**BASRAH INTERNATIONAL AIRPORT –
AIR SIDE POWER SUPPLY TO
NAVAIDS AND VISAIDS
BASRAH, IRAQ**

PROJECT NUMBER SIGIR-PA-06-050

SUBJECT: Basrah International Airport – Air Side Power Supply to NAVAIDS and
VISAIDS, Basrah, Iraq (Report Number SIGIR-PA-06-050)

Figure 2: Excerpt from PDR schematic showing details of the electrical distribution system at the Basrah International Airport

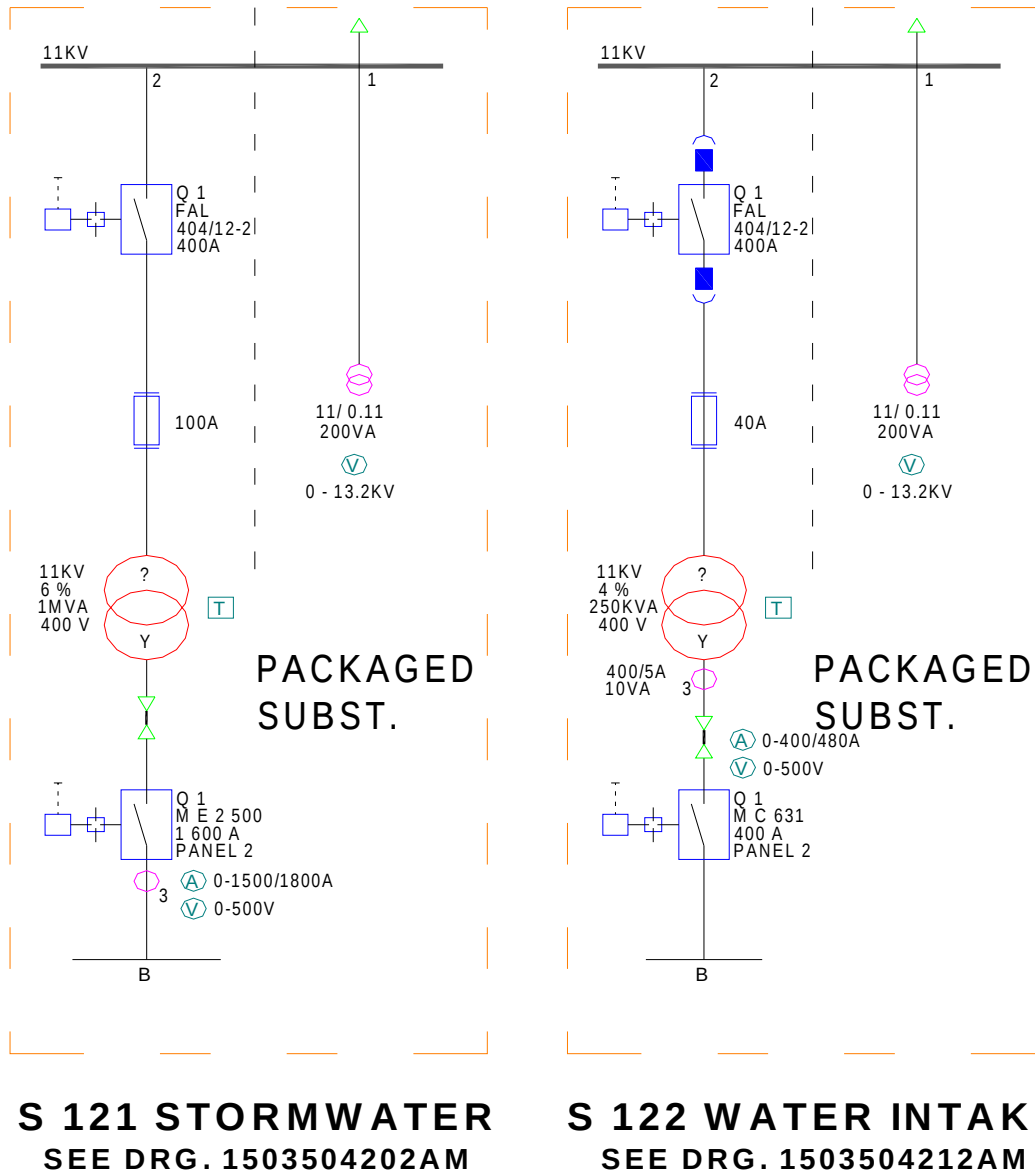
The electrical schematic diagram included the complete BIA MV system with the three MV rings and individual substations. Specific details for the quantity and type of components were included within the schematic. Figure 2 shows an example of a portion of the schematic, which included electrical system details for two of the substations.

The review of the interim PDR, draft PDR, and final PDR showed the submitted reports are consistent with the contract requirements. Although specific scopes of work were not included in the final submittal, the data and schematics should be detailed and specific enough to guide future contracting actions.
